The Board of Vineyard Square HOA has met to discuss your proposal.

Figure 1: Vineyard Square Proposed Path

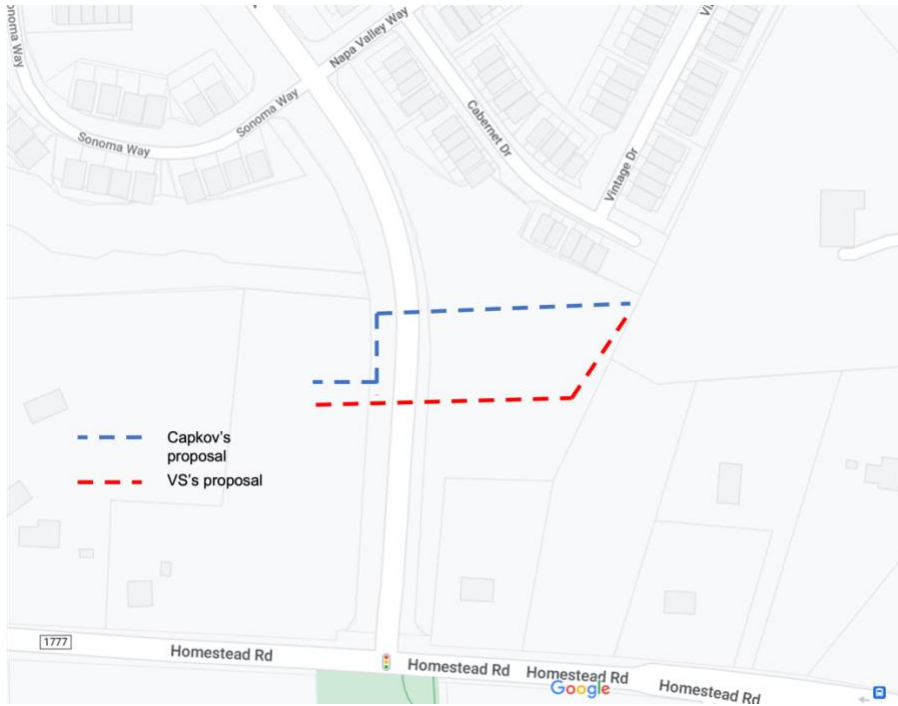
The current nature path compromises the privacy of some of our homeowners. A path giving the view of their rear decks and yards would not be acceptable. We want this to work and thus propose an alternative path that cuts deeper into our woods (highlighted in red on the map below). Our proposal not only solves our privacy concern, but also makes the path more attractive to Chapel Hill residents, providing them a cooler and shaded area in which to walk. But this may require that Parks & Rec commit to maintaining any steps or bridges built over streams and cleaning up the occasional dog poop bag. For the path, we would envision a narrow natural path like the spurs in Chapel Hill North (see pictures below), where all trees are preserved with the path winding around them.
